Oregon State University
Construction Contract Administration
Wilson Hall Roof Replacement

ADDENDUM NO. 3

OSU / Wilson Hall Roof Replacement Project

**WILSON ROOF
REPLACEMENT**

1 WILSON HALL - DEMO PLAN
R100 3/32" = 1' 0"

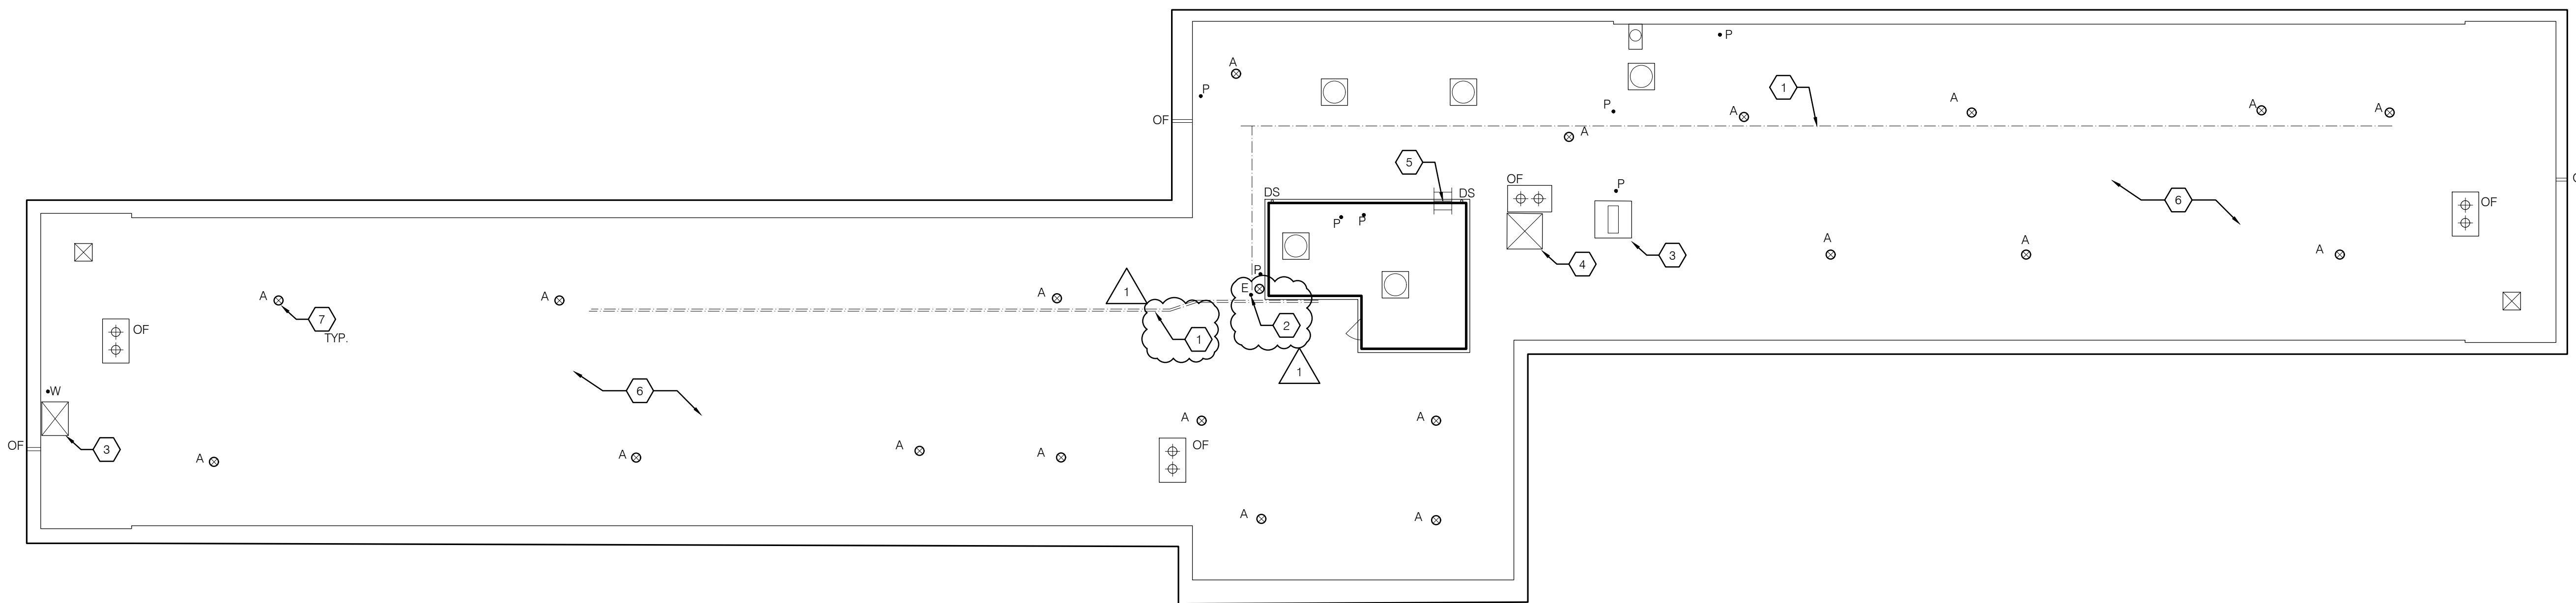
- Item 2 Sheet R100 "Demo Plan", REPLACE in its entirety with sheet R100, dated 05/06/2019. Revised language for Key Notes 1 & 2 (partial drawing). Revised placement for Key Notes 2 (partial drawing). See attached.
- Item 3 Sheet R101 "Roof Plan", REPLACE in its entirety with sheet R101, dated 05/06/2019. Revised Legend of Symbols (partial drawing). Revised roof plan (partial drawing). See attached.
- Item 4 Sheet R201 "Details", REPLACE in its entirety with sheet R201, dated 05/06/2019. Revised detail 3/R201 NOT USED (partial drawing). See attached.

Item	Reference	Description
1.01	<i>Drawing R100</i>	Update sheet R100 with revised language for Key Notes 1 and 2 (partial drawing), attached - Drawing R100.
1.02	<i>Drawing R100</i>	Update sheet R100 with revised placement of Key Note 2 (partial drawing), attached - Drawing R100.
1.03	<i>Drawing R101</i>	Update sheet R101 with revised Legend of Symbols (partial drawing), attached - Drawing R101.
1.04	<i>Drawing R101</i>	Update sheet R101 with revised roof plan (partial drawing), attached - Drawing R101.
1.05	<i>Drawing R201</i>	Update sheet R201 with revised Detail 3/R201 Not Used. (partial drawing), attached - Drawing R201.
